### CERTIFICATE OF APPROPRIATENESS – Minor Alteration

Progressive Old Town  
5 Old Town Square  
Fort Collins, CO 80524

This letter provides you with certification that proposed work to your designated Fort Collins landmark property, the H.C. Howard Block at 214 E. Mountain Avenue/3 Old Town Square has been approved by the City's Historic Preservation Division (HPD) because the proposed work appears to be routine in nature with minimal effects to the historic resource, and meets the requirements of Chapter 14, [Article IV](#) of the Fort Collins Municipal Code. Please note conditions on the two proposed work items on the building's exterior.

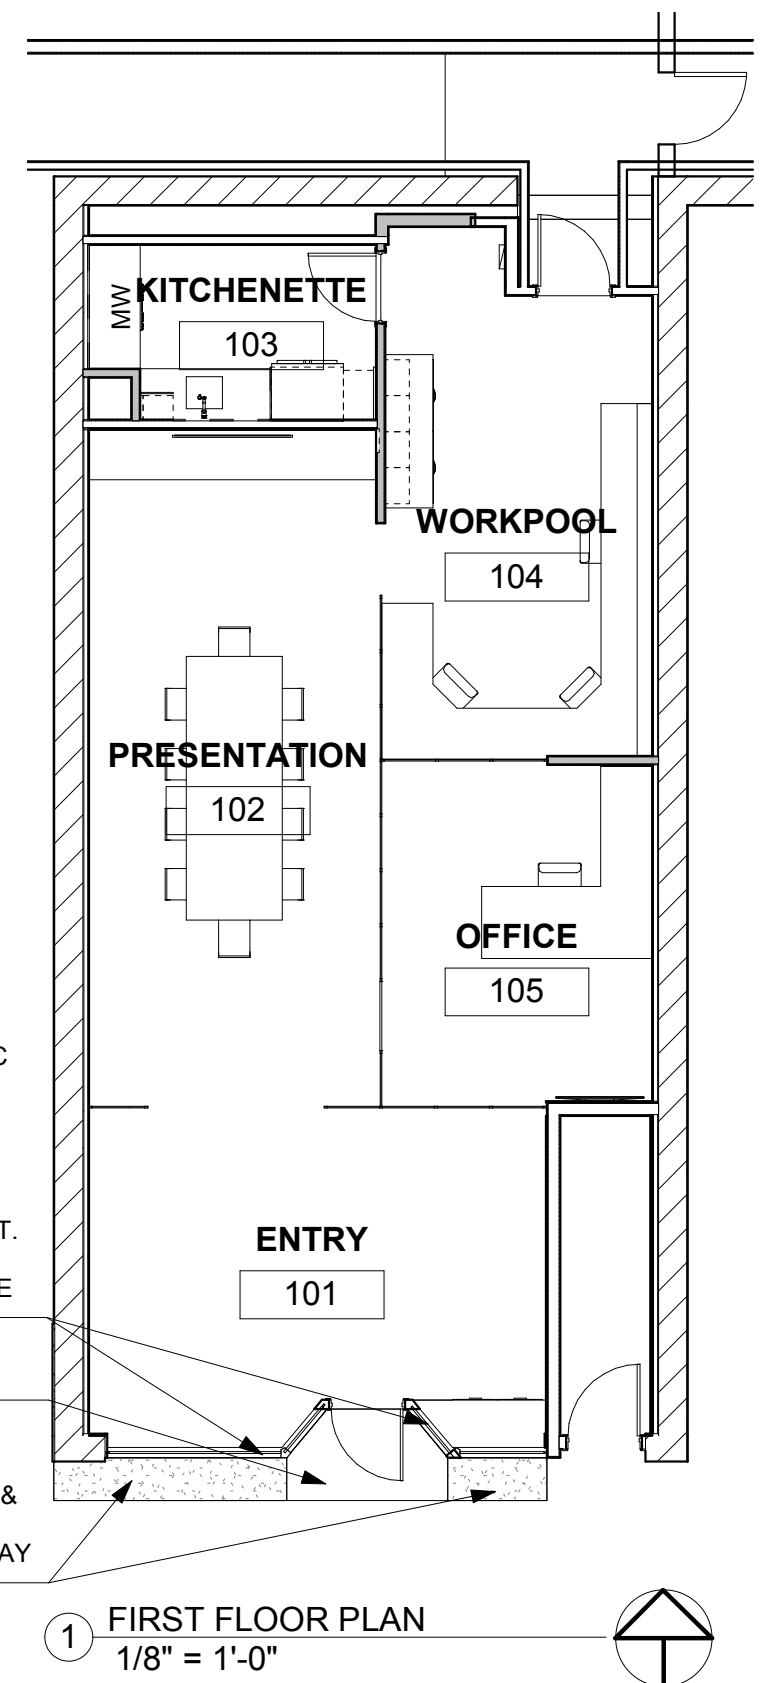
- Minor carpentry repair to wood store front, subject to the following conditions:
  - *Condition 1: Replacement of wood features due to deterioration will be limited to the wood framing at grade that was previously noted as deteriorated. Replacement shall be in-kind (i.e., same dimensions and same or similar wood material). If, after removal, field conditions require replacement of further wood framing (kick plate, window framing, etc.), the applicant will contact Historic Preservation Services immediately for a consultation prior to altering the approved work.*

- *Condition 2: Wood repair that requires heavy sanding or other abrasive measures will not be used.*
- Repaint of wood elements of exterior
  - *Condition 1: Application of water sealants, including waterproof wood treatments or waterproof paints is generally discouraged and will require additional consultation with Historic Preservation Services.*

- *Highly abrasive paint removal methods such as use of rotary sanders or sandblasting are discouraged due to likelihood of damage to the underlying material and will require additional consultation with Historic Preservation Services.*
